USING G100034 WE PREPARED A SPACER CONCEPT AND EXCHANGED AN IDEA WITH MIKE MEYER PAGE 3 OF THIS RED-LINE INDICATES FEEDBACK AND HOLE POSISITONS AGREED BASE DON THIS SKETCH.

NOTES AND TOLERANCES: (UNLESS OTHERWISE SPECIFIED)		LIGO CALIFORNIA INSTITUTE OF TECHNOLOGY MASSACHUSETTS INSTITUTE OF TECHNOLOGY		PART NAME HSTS SPACER CONCEPT, HAM2-H1 MC1, MC3						
DIMENSIONS ARE IN INCHES		SYSTEM ADVANCED LIGO		SUB-SYSTEM SUS		DESIGNER E. Shankle	27 JAN 2010	SIZE D	DWG. NO. G1000034	REV. v4
TOLERANCES: .XX ± N/A .XXX ± N/A		NEXT ASSY D020023		CHECKER C. TORRIE		27 JAN 2010		SCALE: 1:5		
ANGULAR ± N/A °		FINISH N/A μinch		APPROVAL C. TORRIE		27 JAN 2010		PROJECTION: [Symbol] SHEET 1 OF 1

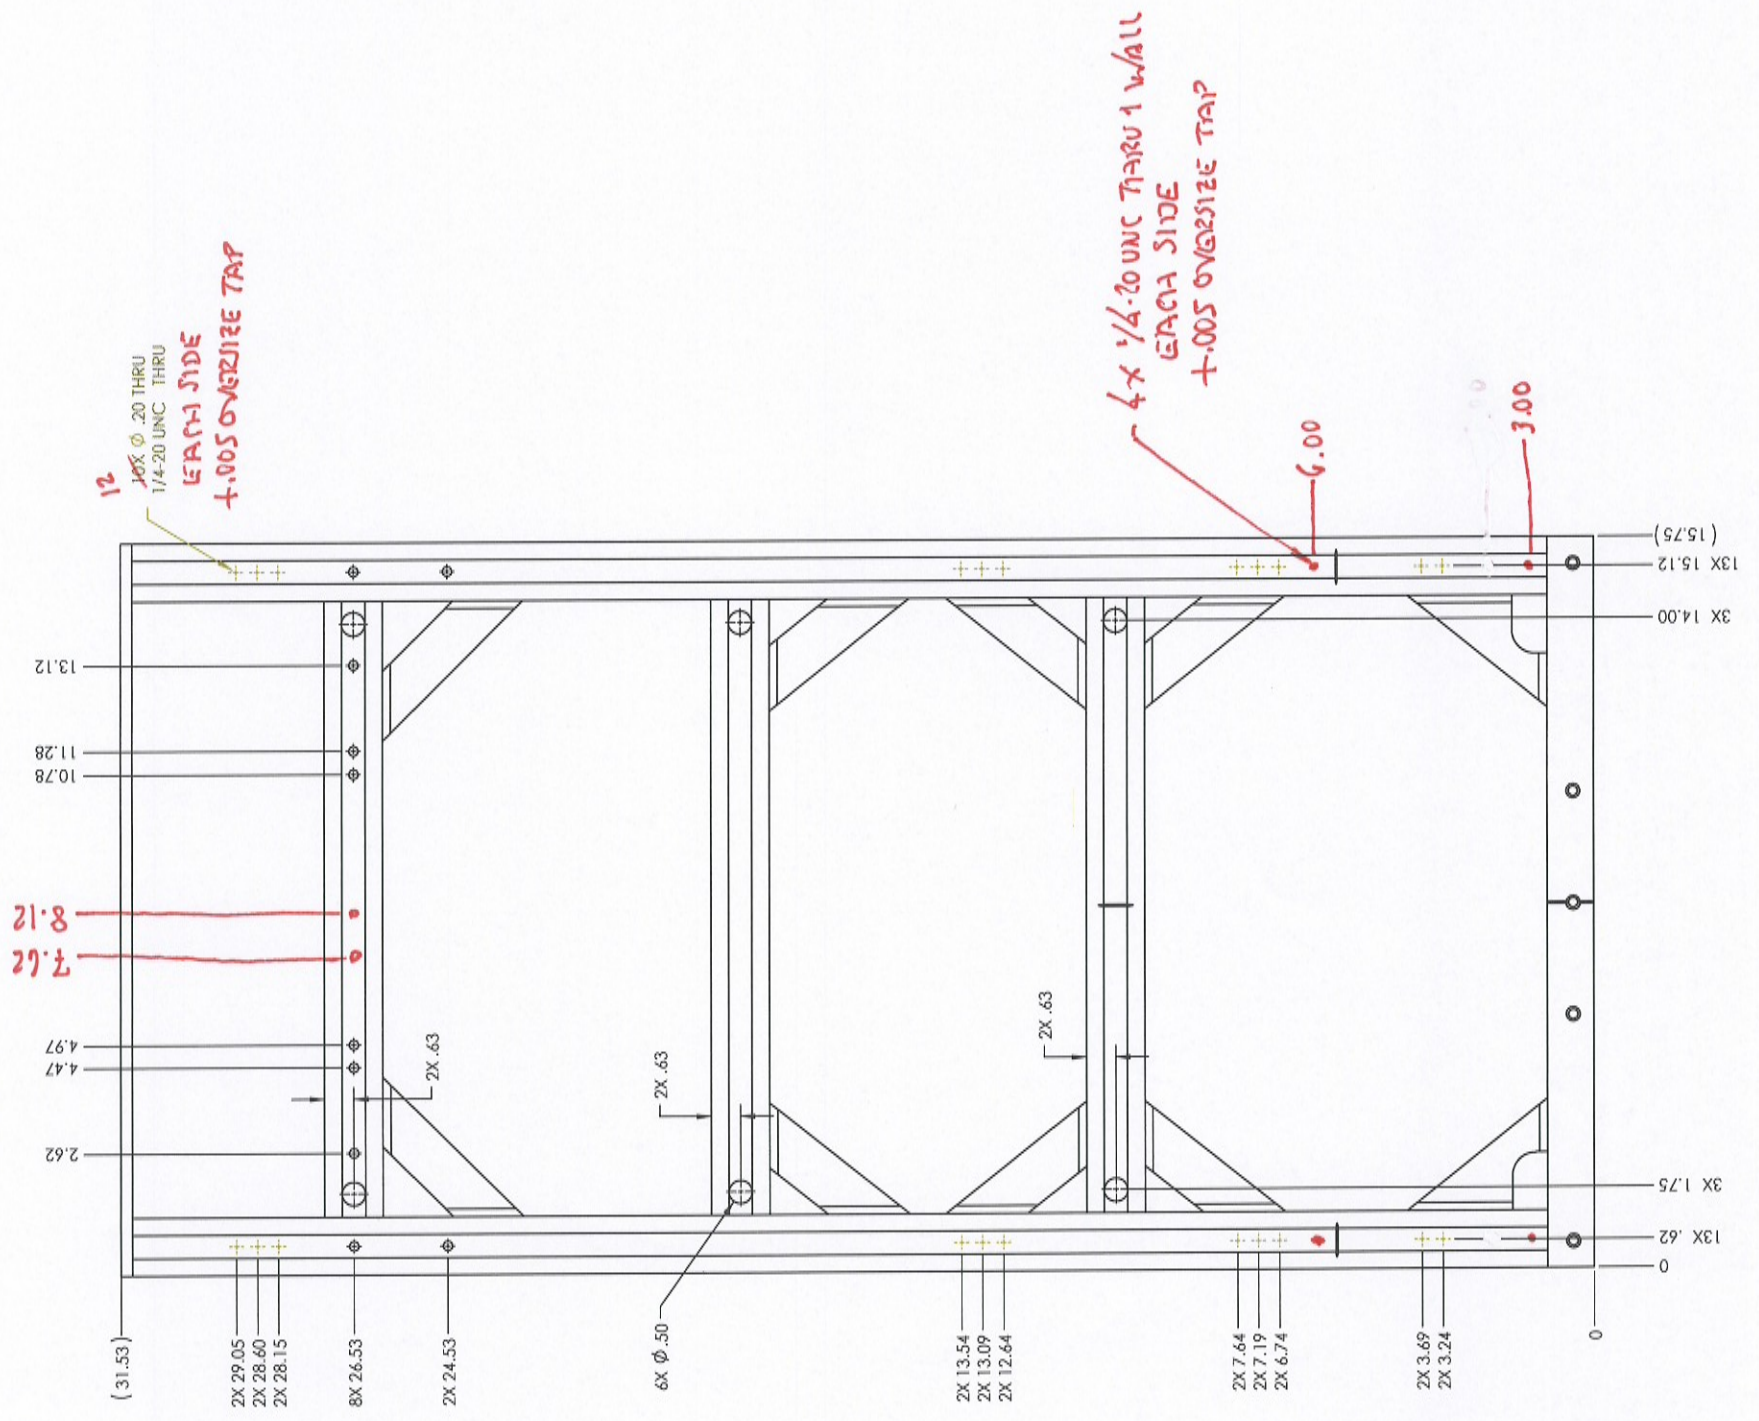
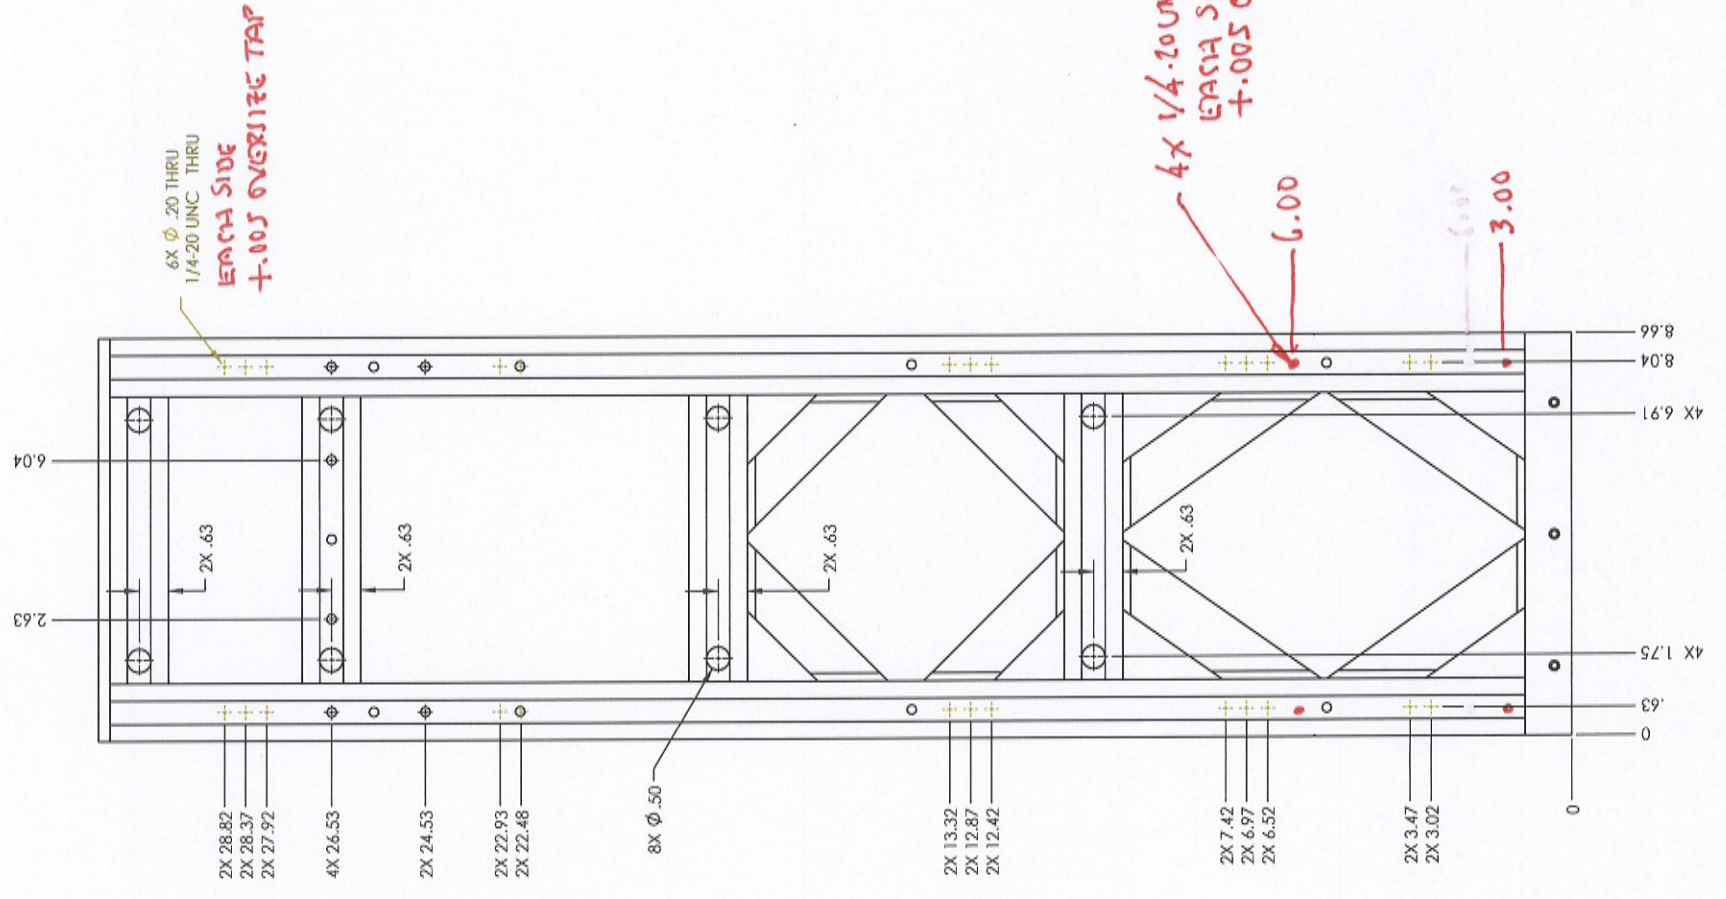
SHEET 1 SHOWS ADDED HOLES  
REQUIRED FOR DAMPING STRUTS &  
CORNER DAMPING PADS

DETAIL C  
 SCALE 1 : 1.5

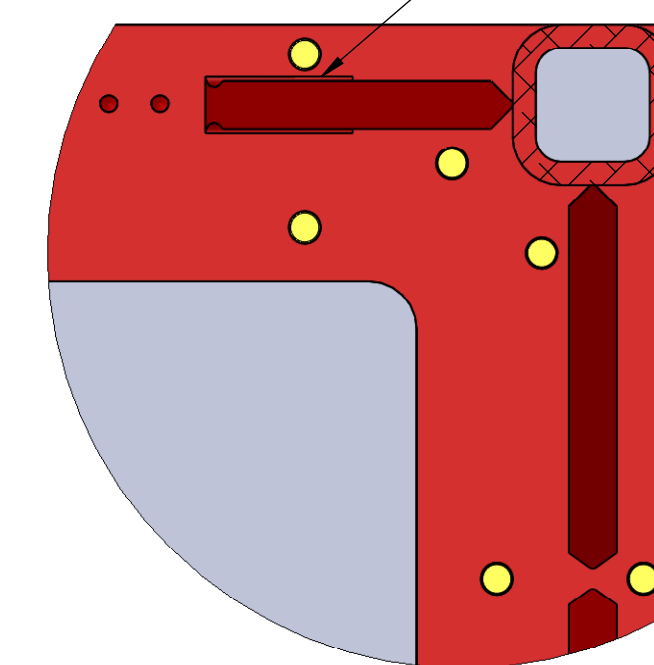
NOTE:  
 THRU HOLES ARE IN VERY CLOSE PROXIMITY TO WELDED FILLET TYP
